Official Transcript of Proceedings
NUCLEAR REGULATORY COMMISSION

Title: Advisory Committee on Reactor Safeguards
Regulatory Policies and Practices

Date: Tuesday, February 2, 2016

REGULATORY POLICIES AND PRACTICES SUBCOMMITTEE

Figure 3-3 Comparison of NUREG/CR 7110 Vol 2 and UA steam generator nodalizations

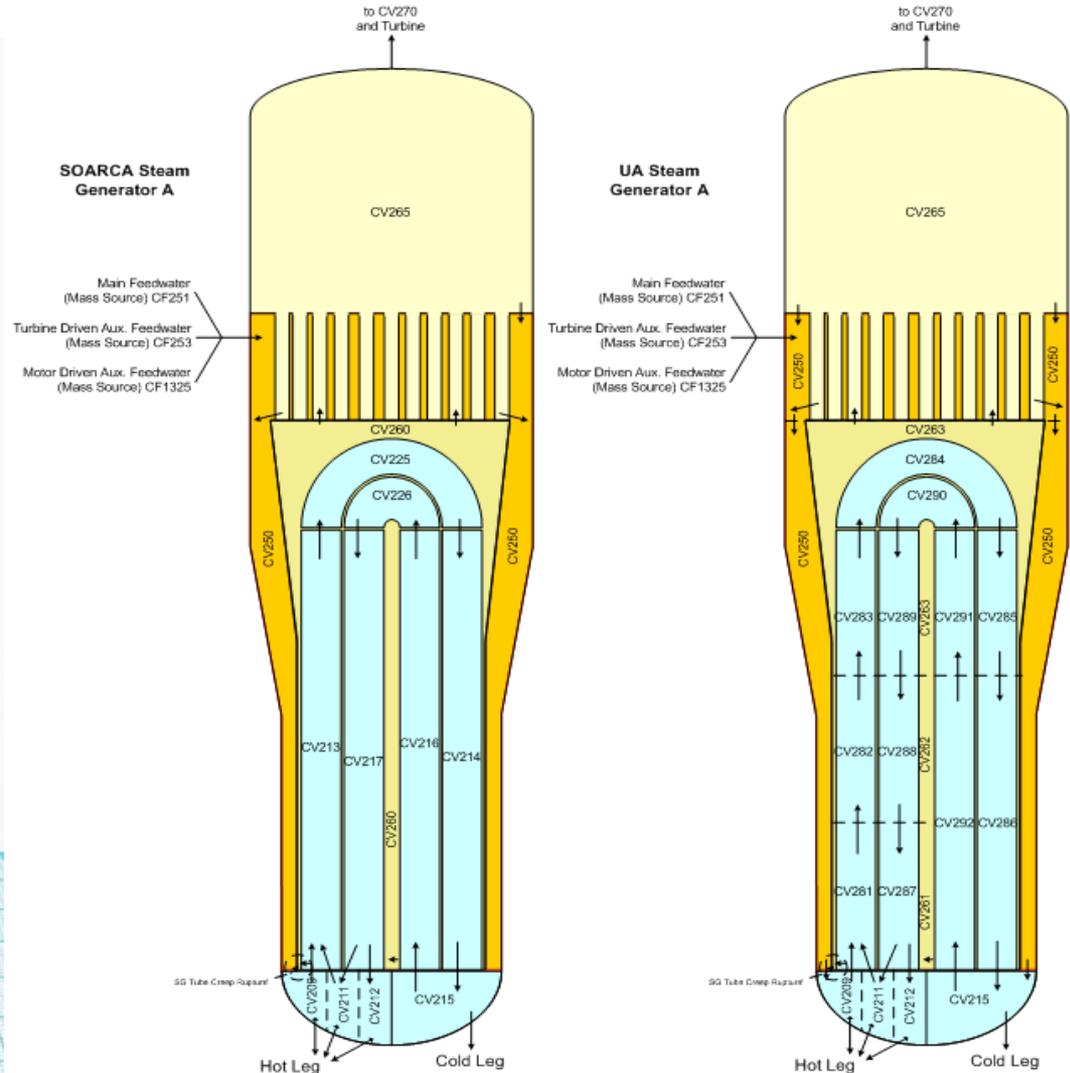
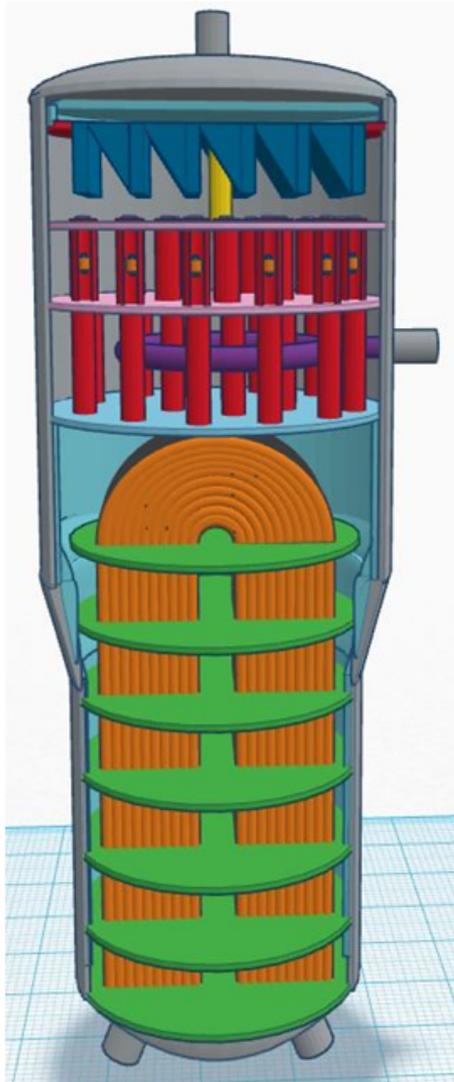
11 MEMBER CORRADINI: So you had - so you
12 had more control volumes in the tube sheet? I'm
13 just trying to look at the difference. I only see
14 more control lines in the tube sheet. Is that
15 correct?

13 But there was a local or a hot tube
14 analysis that really focused close to the tube
15 sheet to make sure that we were able to capture the
16 hottest part of the flume entering the speed
17 generator.

Figure 4-1 Possible transitions in the 3-SV pressurizer pressure relief system considering both FTO and FTC valve conditions

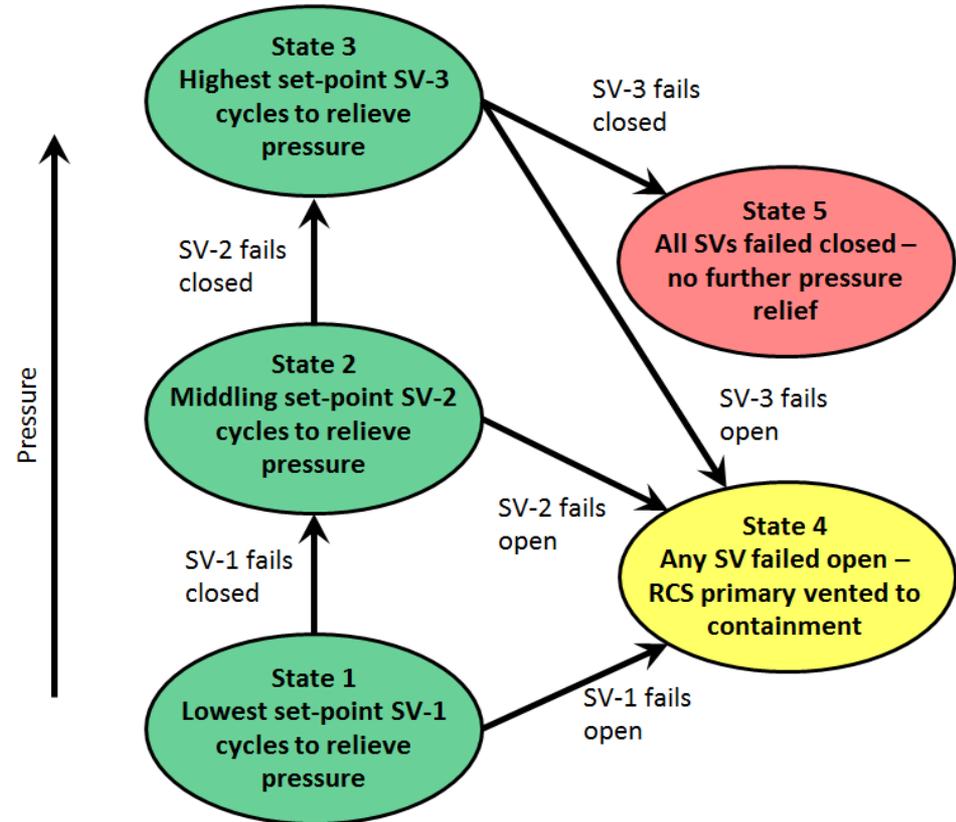
2 MEMBER SKILLMAN: I'm reading the text on
3 what is page 402, I think it's A3 or A4, is A4, and
4 here's the question. In the second paragraph on
5 page 402, the words that are presented are these
6 words: "The safety valves on the pressurizer begin
7 opening and closing to remove excess energy."
8 Operative word is safety valve, meaning spring, and
9 probably blow down rate, safety valve. Next
10 sentence: "The pressurizer relief valve flow causes
11 a steady decrease in the primary system's coolant
12 inventory." I believe the second sentence is really
13 clarifying the first sentence but instead of safety
14 valve what is written there is pressurizer relief
15 valve, and I would ask if that's what the author
16 really intended because those are different pieces
17 of hardware.

14 MEMBER SKILLMAN: It is the second
15 paragraph from the top. And I make that comment
16 because the safety valves really are the large
17 spring valves, and a relief valve is commonly
18 actuated by some other medium. Right?

20 MR. WAGNER: Same piece of hardware, and
21 Surry has some funny names for these things. We've
22 -- the first sentence would be correct, "spring
23 operated."
